SITE AUDIT REPORT AND SITE AUDIT STATEMENT

Caddens Release Area C, Kingswood, NSW, 2747

Report Number. 097623019_014_R_Rev0

Figure 12 Groundwater Flow

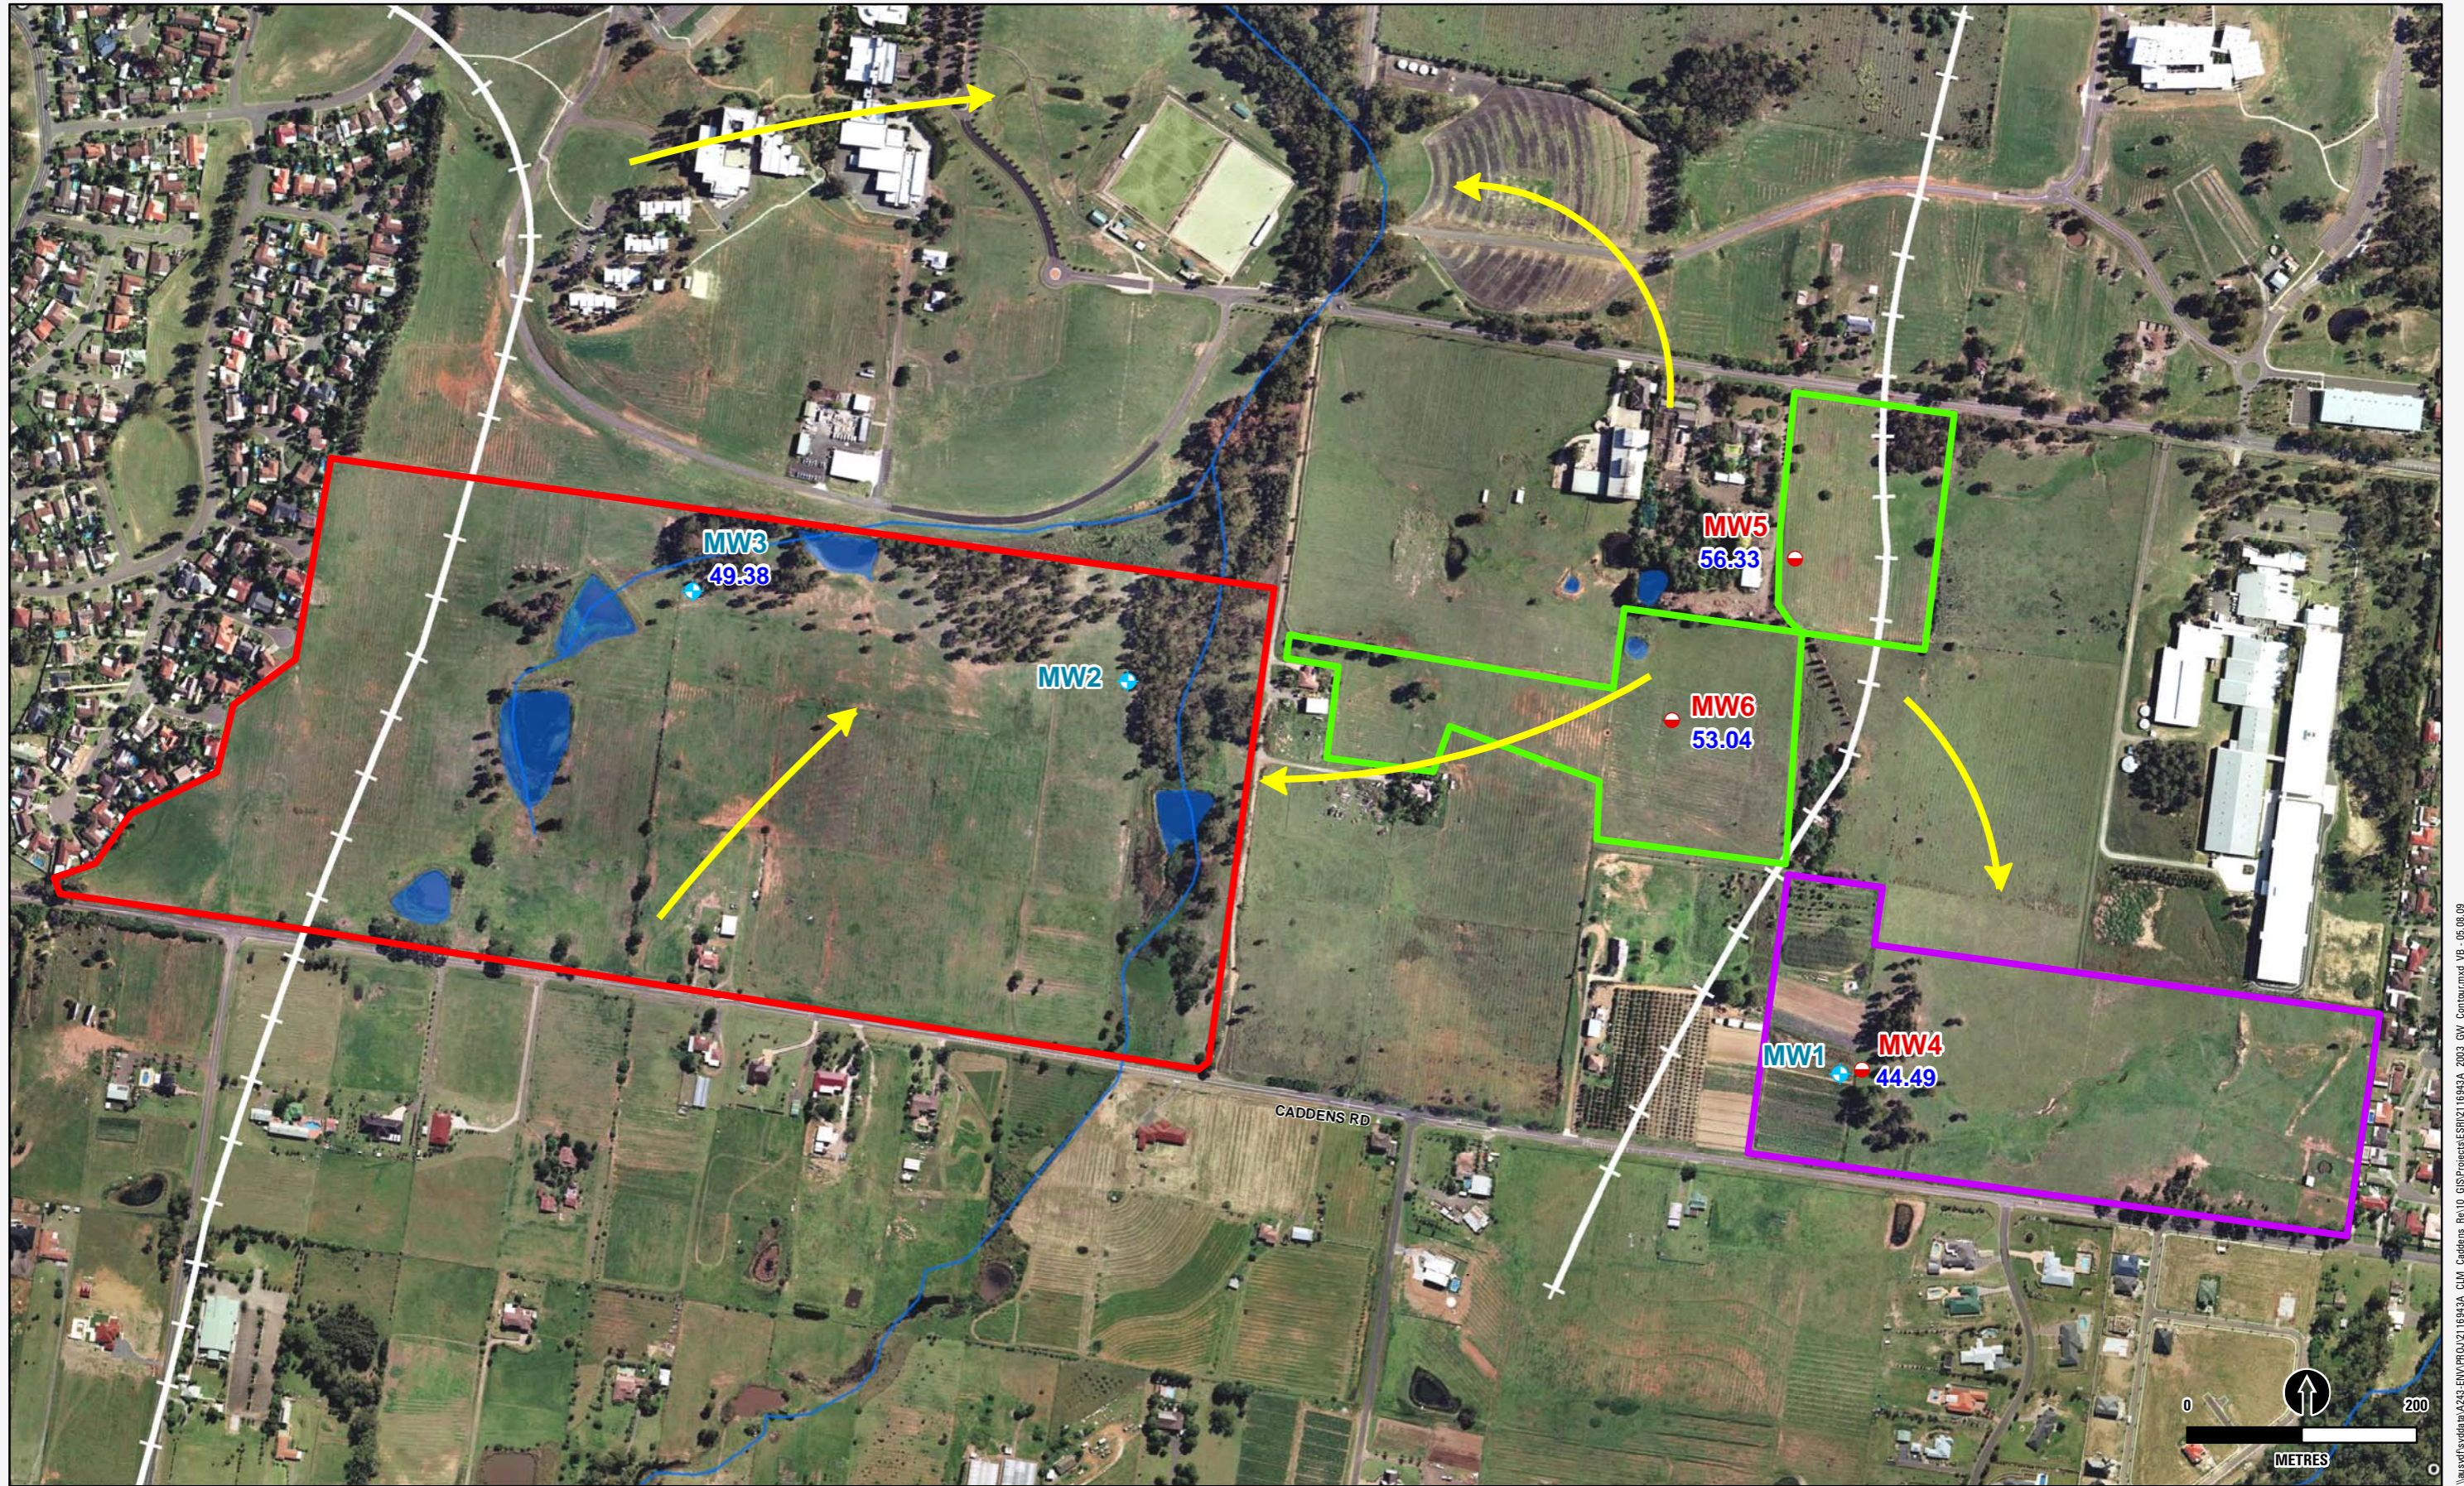
Table 8-4 references Figure 12 which presents interpreted groundwater contours which are plotted to flow in a southerly direction radiating from well MW5. This interpretation contradicts the direction of flow inferred from published information (Section 3.4), and the direction of flow of the creek that bisects the Site.”

The Site is bisected by Werrington Creek that flows to the north. Monitoring wells MW4-MW6 and MW3 are located on the western side eastern side of the creek respectively. The interpretation of groundwater flow on Figure 12 (PB, 2009b) was undertaken incorrectly by contouring the elevation of the watertable and ignoring the influence of the drainage lines. It is assessed there is insufficient data to contour the groundwater elevation to produce a potentiometric head contour map.

Reference to the topographic map indicates the Site is intersected by catchment boundaries to the east and west as shown on Figure 12. The watertable elevation in an unconfined aquifer is typically a subdued reflection of the topographic surface. Groundwater flow is inferred to be perpendicular to the catchment boundary and towards the creek systems. Thus groundwater flow at the eastern part of the Site is radial from MW5 (centred on a local topographic high) and elsewhere generally northward flowing in the direction of Werrington Creek. Analysis of groundwater levels from monitoring wells MW4, MW5 and MW6 confirm local groundwater flow (in the south eastern part of the Site) is in a south-westerly direction towards Werrington Creek.
